# New England Highway upgrade between Belford and the Golden Highway

Submissions Report

Roads and Maritime Services | July 2018

Prepared by Arup and Roads and Maritime Services  
RMS.18.900  
ISBN. 978-1-925797-52-7

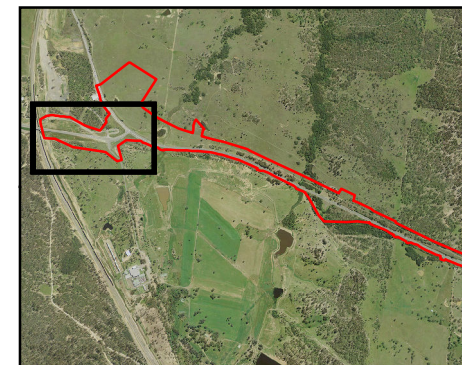
During display of the REF, safe operation of the u-turn facility for access to and from the abattoir and properties to the north of the Golden Highway was raised as a concern. As a result, the concept design has been modified. The proposal now includes a four-leg roundabout approximately 350 metres from the intersection of the Golden Highway and New England Highway, as shown in Figure 3-1. This replaces the u-turn facility assessed as part of the REF.

The roundabout provides a consolidated access for lots to the north and south of the Golden Highway. As part of this change, the abattoir access road has been realigned to connect to the roundabout. Properties to the north will access the roundabout via a service road using the old Golden Highway alignment. The proposed changes would maintain safe access to the eastbound flyover entry ramp for all vehicles and removes the need for vehicles to merge with Golden Highway traffic.

The existing access at the abattoir will be decommissioned once the new roundabout and access road is completed. The new access road will be located within the abattoir property. No additional property acquisition is proposed.

Figure Title  
**New England Highway and Golden Highway intersection**

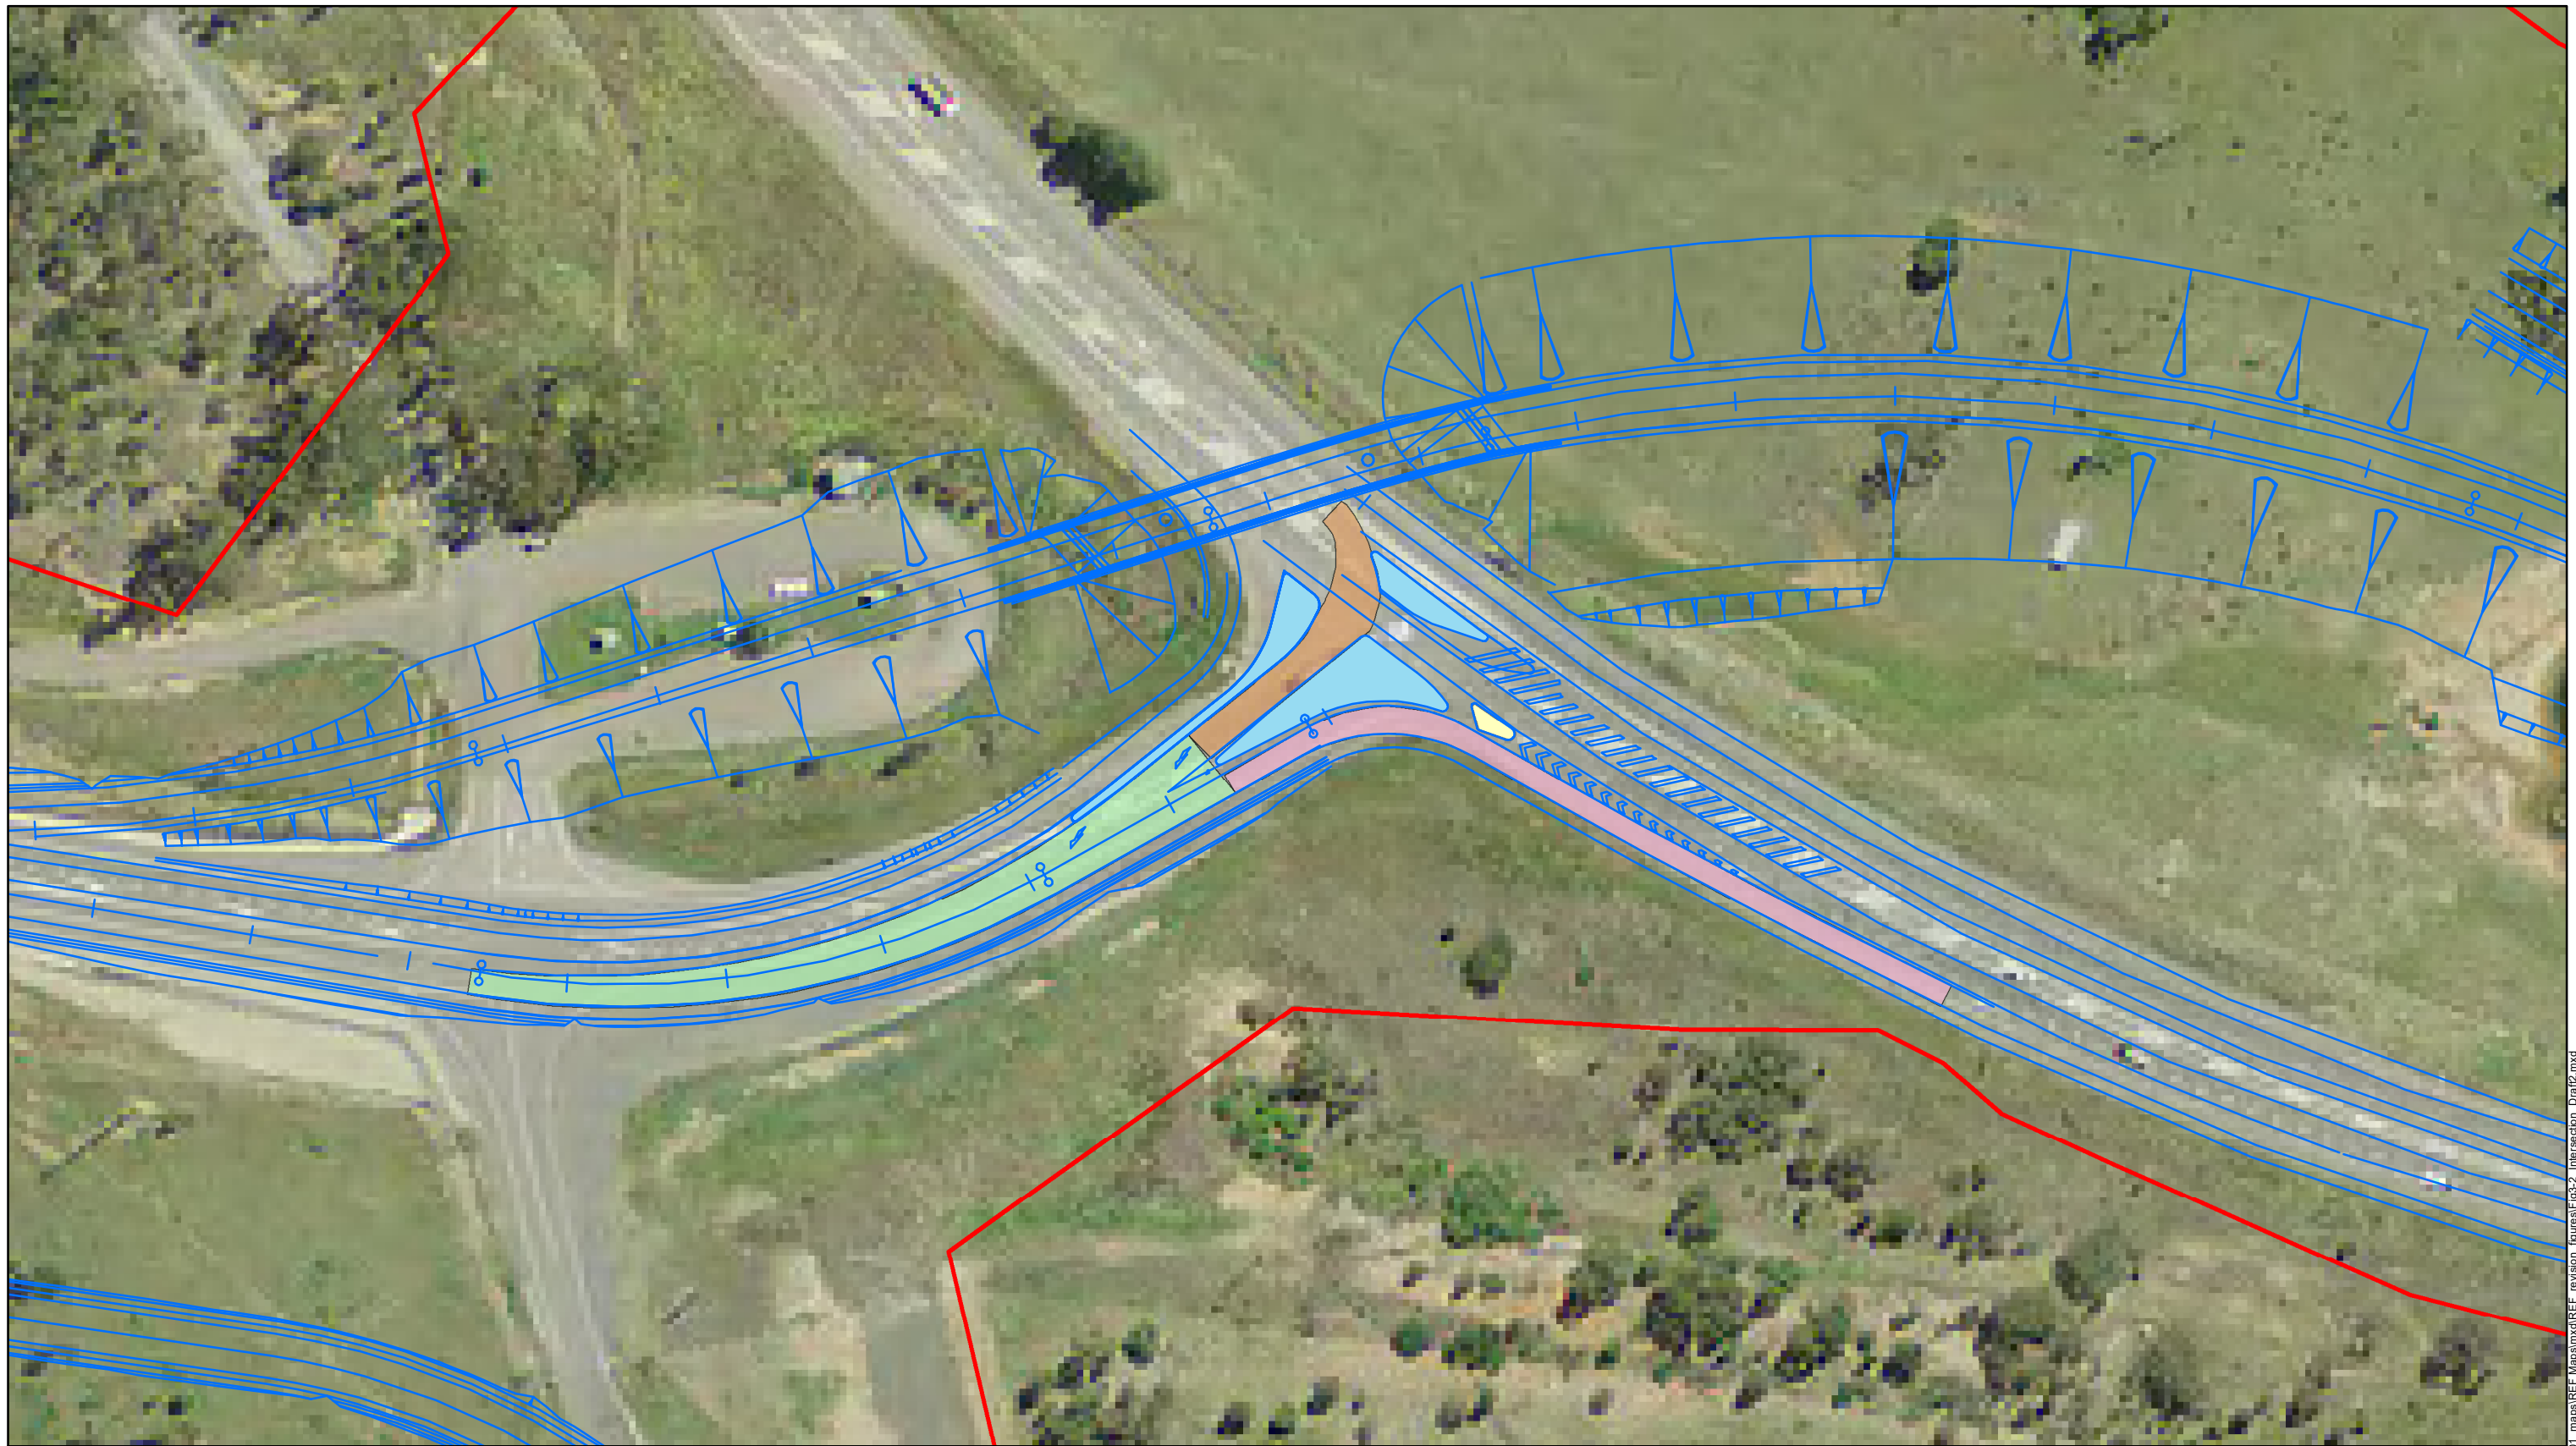
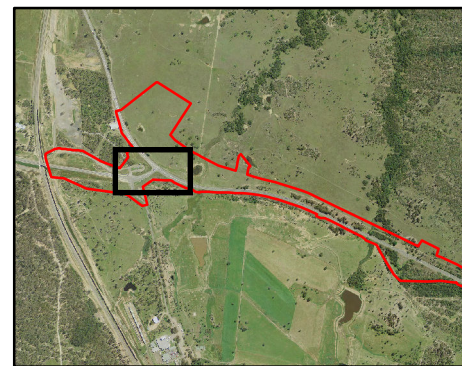
Since display of the REF, the intersection of the New England Highway and Golden Highway has been modified in response to the submissions received. These modifications will reduce potential conflict between vehicles and improve the safety at this intersection.

Improvements to the intersection include:

- Removal of the existing give-way sign and linemarking at the New England Highway left turn lane
- Raised traffic islands at the intersection to provide improved delineation for all turning movements, including separation between vehicles
- Provision for vehicles turning onto the Golden Highway to merge west of the intersection.

Figure Title  
**Median**

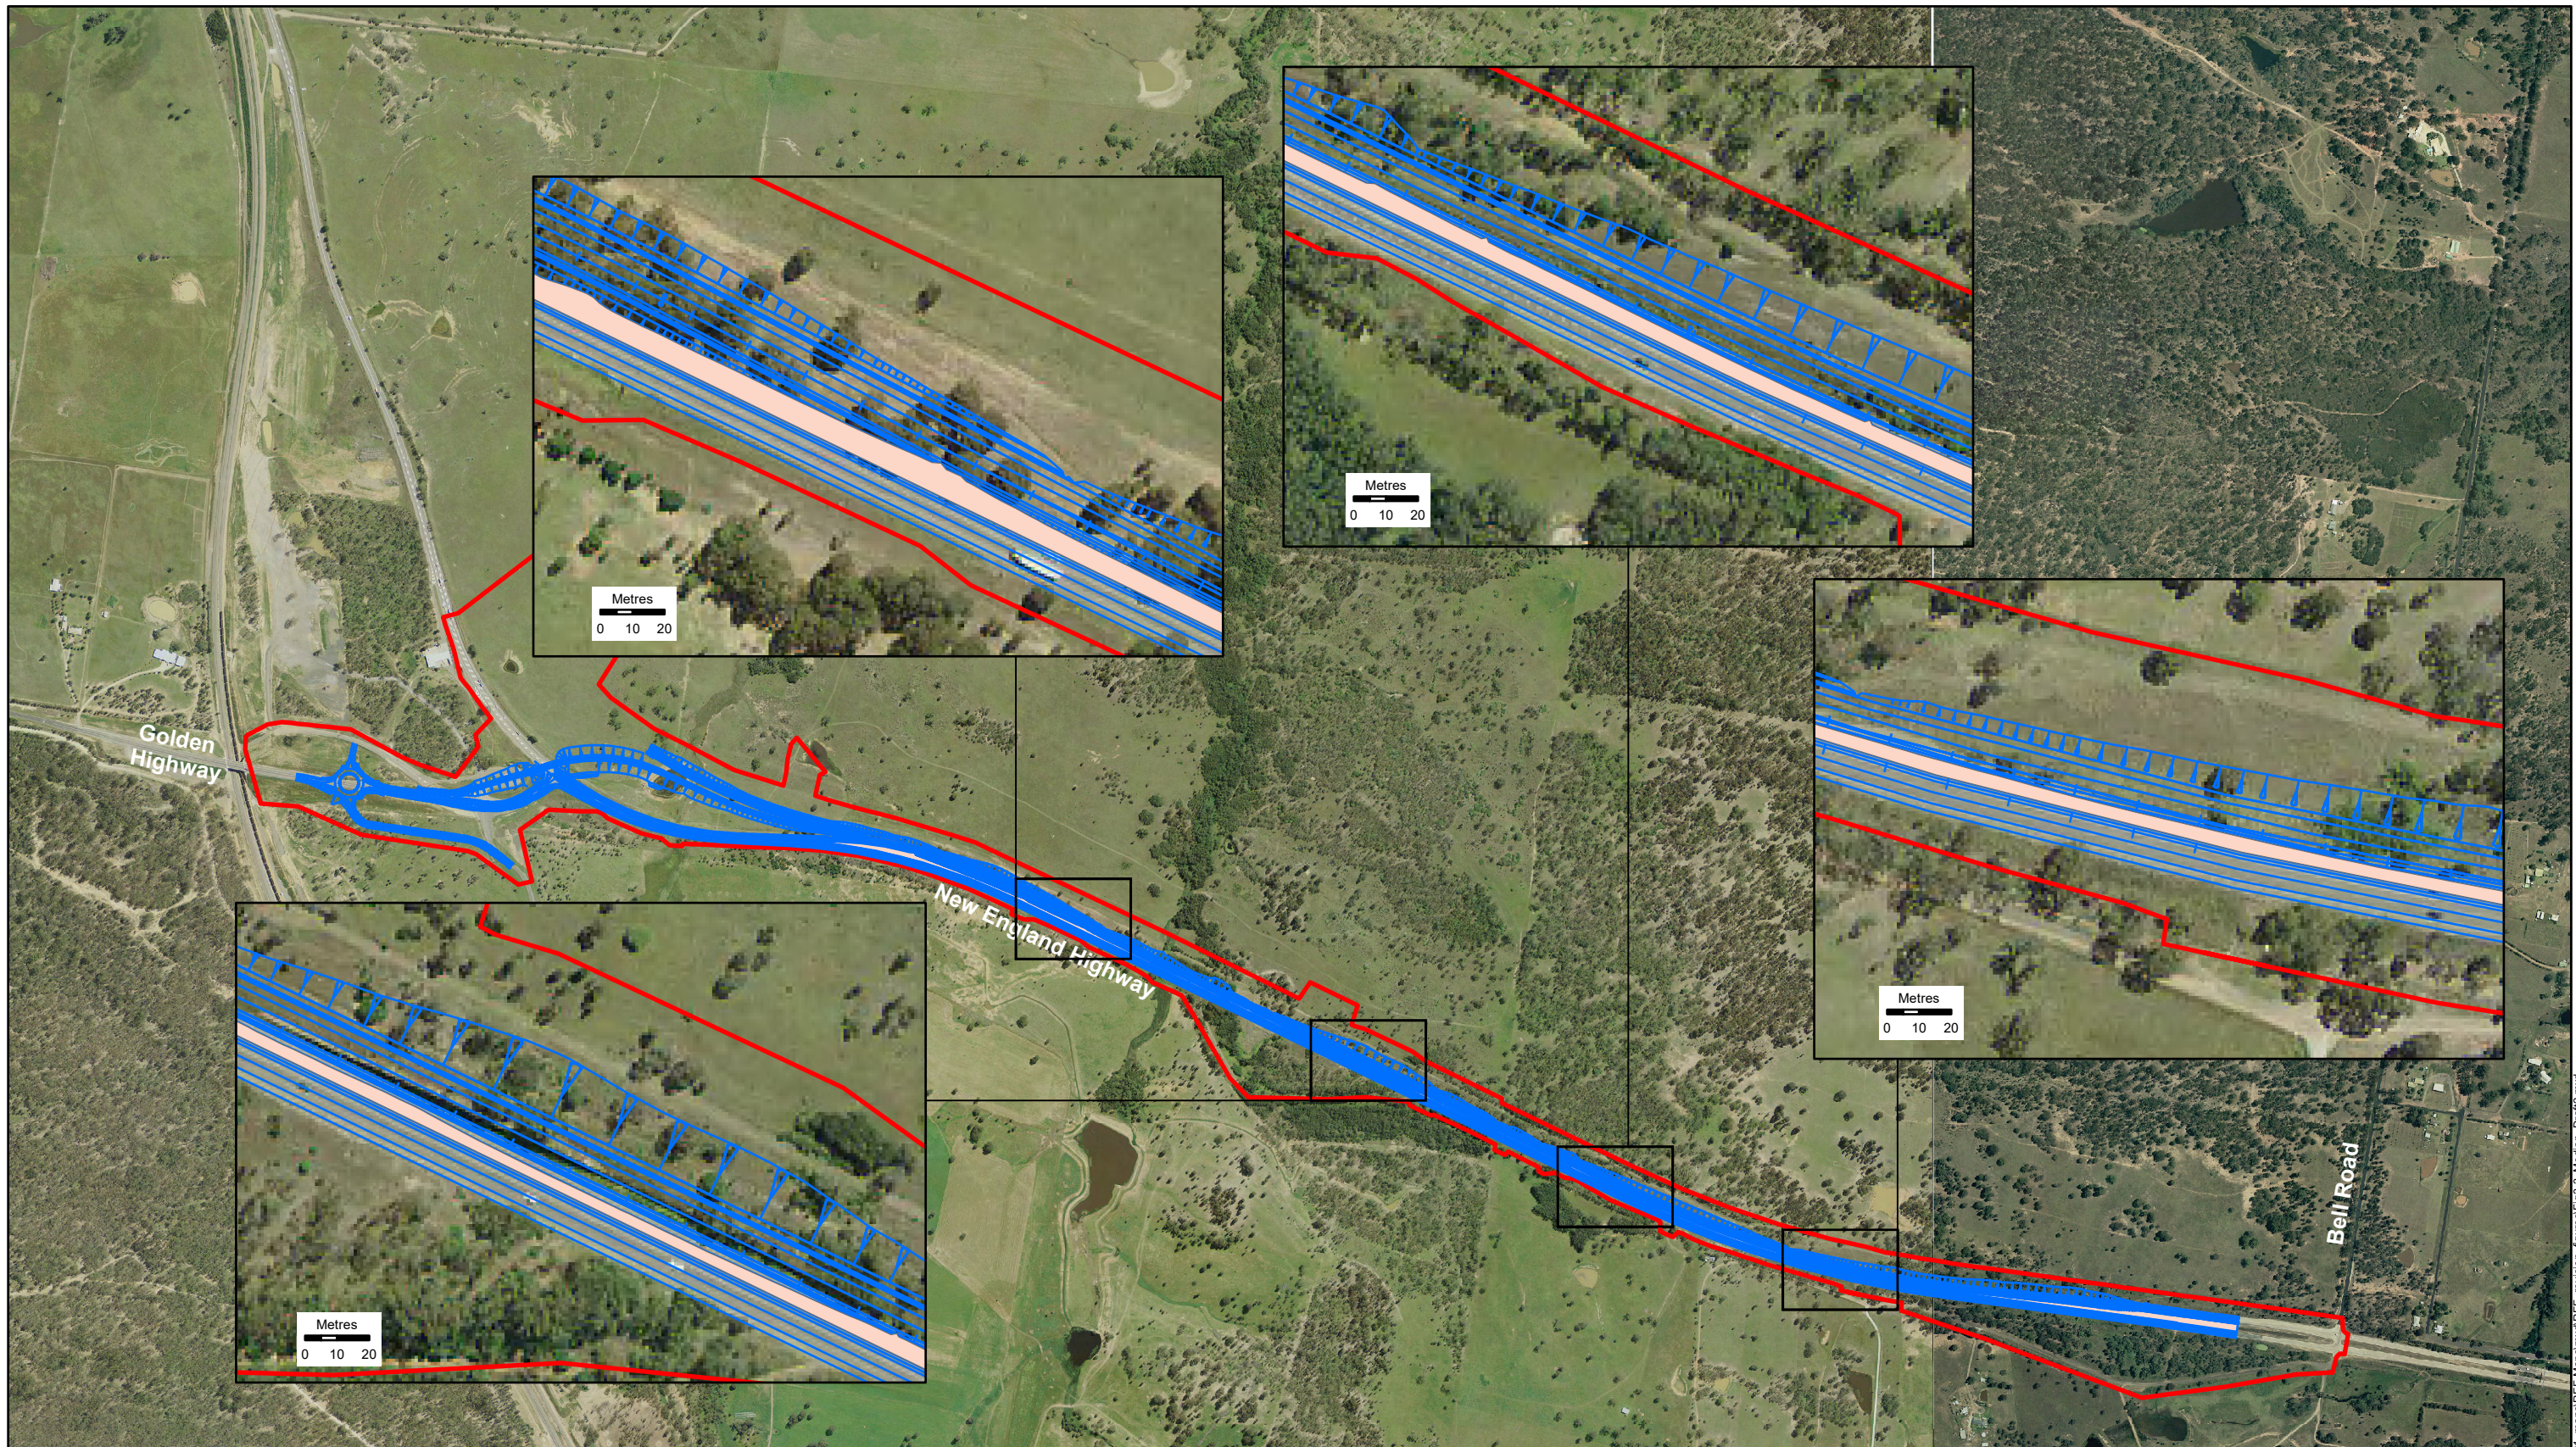
Since the display of the REF, Roads and Maritime has reviewed the long term strategic upgrade of the New England Highway. This review identified an opportunity to reduce the footprint of the work. One aspect of this change is to reduce the width of the median from the previously proposed 12 metres to a minimum 8.5 metres.

The reduced median width between the New England Highway eastbound and westbound travel lanes provides the following opportunities:

- Reduced footprint of road infrastructure in several areas on the northern side of the New England Highway
- A reduction in property acquisition
- Reduced impact on utilities in terms of extent of proposed fill above the underground critical gas main that runs along the northern side of the New England Highway, resulting in a reduced length of the gas main needing protection
- Potential for reduced costs due to shortened culverts.

This does not change the proposed capacity for the New England Highway, as two lanes in both the westbound and eastbound direction are retained as part of the design. It is also proposed to install a safety barrier in the median along the length of the New England Highway to Bell Road.
